Re: Cases 144477 and 78 Chesapeake's Chambers Strawn Unit and Waterflood

# Proposed Chambers Strawn Unit

**Isopach Map of Mound Containing Chambers 1 and Chambers 2**  
 This mound is just southwest of the Proposed Chambers Strawn Unit  
 Map is based upon interpretation of 3-D Seismic data and Well Log data

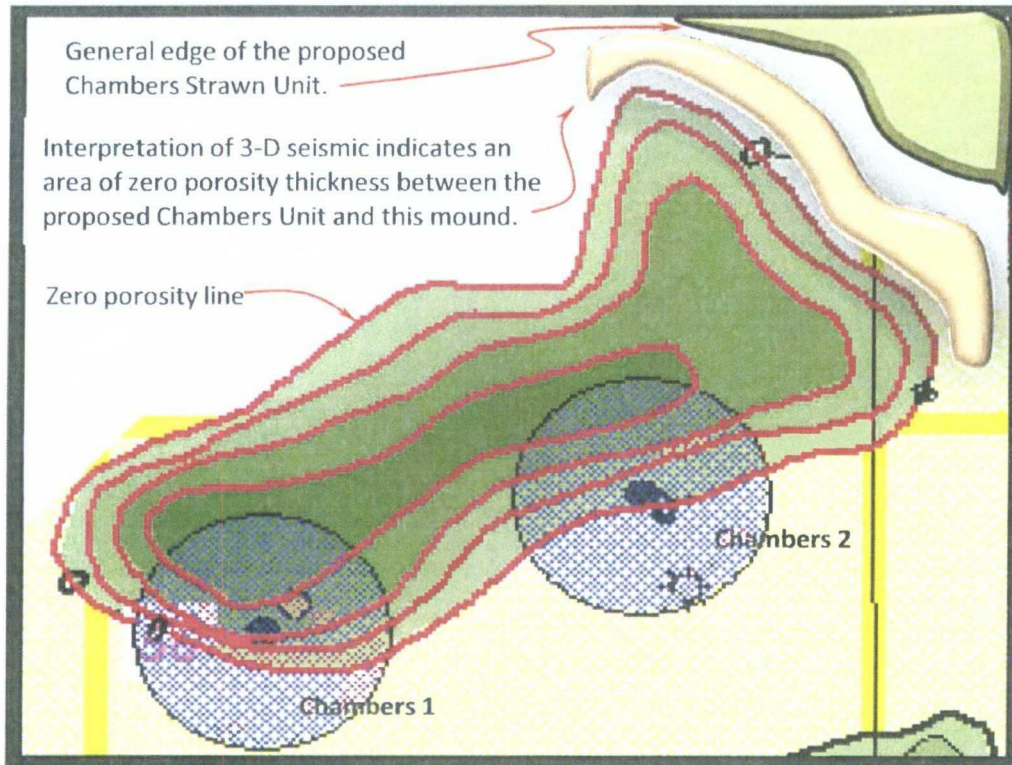
We considered the possibility of placing the Chambers 2 well into the Chambers Unit but concluded that the Chambers 2 was in a separate mound and did not have effective pressure communication with our proposed mound. Two items lead to this conclusion: seismic interpretation and well performance.

Well performance supports the concept of separate mounds. The first well drilled in this area was the Chambers 1, which came on March 1974 with virgin pressure and a first month rate of 506 BOD and 868 McfD. This well's estimated ultimate recovery (EUR) is 443,908 BO and 1,104,130 Mcf; it has been a very strong well. The second well, the Chambers 7-1, was drilled 22 years later. It also came on with virgin pressure; it had a first month rate of 415 BOD and 733 McfD. This well's EUR is 529,950 BO and 1,853,355 Mcf, also a very strong well. The behavior of these wells indicates that they are in separate mounds with no pressure communication. The proposed Chambers Strawn Unit mound had the Alston 8-1 drilled in the next seven months and the Runnels 8-1 drilled 10 months later. Each well came on with lower pressure and lower rate and smaller EURs, as detailed in the "Well, Reservoir Data" attachment 5 to the Feasibility Study, and attached here for convenience. These wells indicate the continuous nature that exists within the mound and leads to the belief that these three wells are pressure communicated within the same mound. The Chambers 2 was the last well drilled in this area. The Chambers 2 started production September 2003 with initial monthly production averaging 75 BOD and 95 McfD with an EUR of 51,460 BO and 58,949. This is the weakest well in the area; it had clearly suffered pressure depletion and is

only 1436 ft. from the Chambers 1. We believe that well and mound performance add to the credibility of the concept of two separate mounds.

Will, we hope the suggested language of the Unitized formation clarifies and constrains the Unitized formation to the Strawn formation and that the discussion and additional map adds to your understanding of our thoughts on separating the Chambers 2 from the proposed Chambers Strawn Unit. Please let us know if there are additional concerns.
